# Product Change Notification

**Change Notification #:** 119029-00  
**Change Title:** Select Intel® Wi-Fi 6E AX211 (Gig+),  
PCN 119029-00, Label, Manufacturing Site  
Label and Manufacturing update  
**Date of Publication:** April 15, 2022

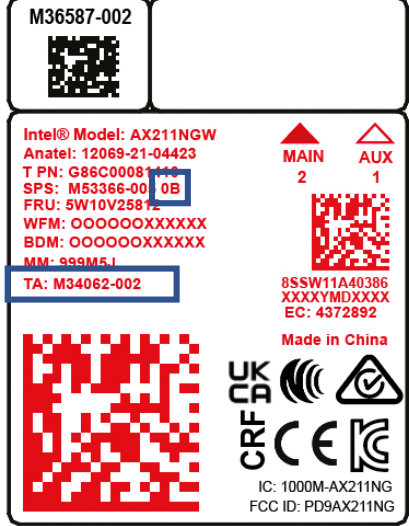
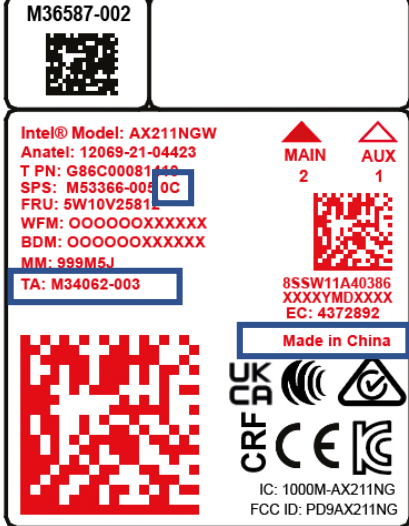
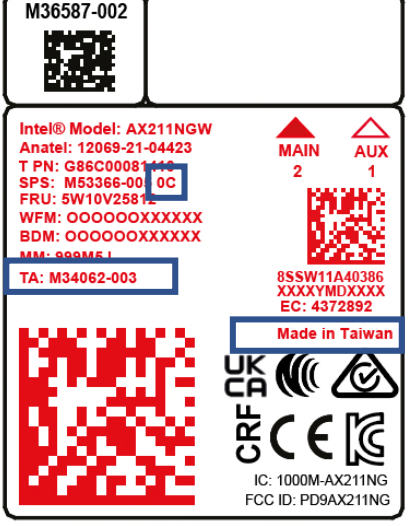
- 1) To increase manufacturing flexibility, an existing manufacturing site in Taiwan is being added for Intel® Wi-Fi 6E AX211. There is no change to the existing Intel® Wi-Fi 6E AX211 design, fit, form, function, software, performance, regulatory, etc.
- 2) The Intel Tracking revision will be changed on the following products.

Product Code	Before	After
AX211.NGWG	0B	0C
AX211.NGWG.NV	0B	0C

- 3) Product TA# dash up.
